SPECIAL USE EXCEPTION PETITION REVIEW REPORT

Petition Number: SUE 20-11

Project Name: Champion Car Care Automotive Repair

Requested Action: Special Use Exception for:
Automotive Use

ADAMS SITE PLAN
SCALE 1/32"=1'-0"
NORTH

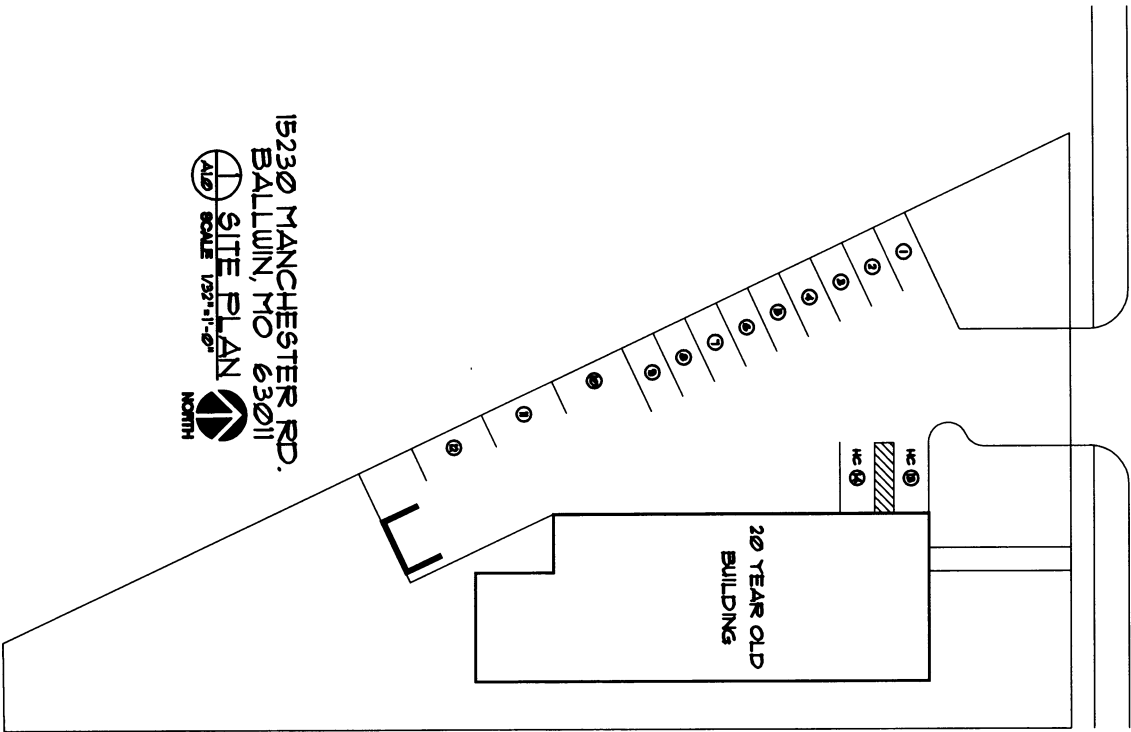
- Art. IX, Sec. 4 (4) refers to improvement of a C-1-zoned parcel with single-family dwellings, and is not pertinent to this evaluation.
- Art. IX, Sec. 5 (1) refers to off street parking and loading spaces, this petitioner is not making any changes to either the currently existing building or its parking lot. The previous tenant for the location was Midas Auto Shop, so there is precedence for this location to operate adequately with the parking it currently has. In reference to my predecessor's evaluation for the previous tenant, the 3 spaces within the service bay in addition to the 14 spaces in the lot provide the minimum of 17 parking spaces.

- Art. XIV, Sec. 2 (10) refers to adequate area for the use. The amended site development plan provides evidence that it has more than the minimum area sufficient.
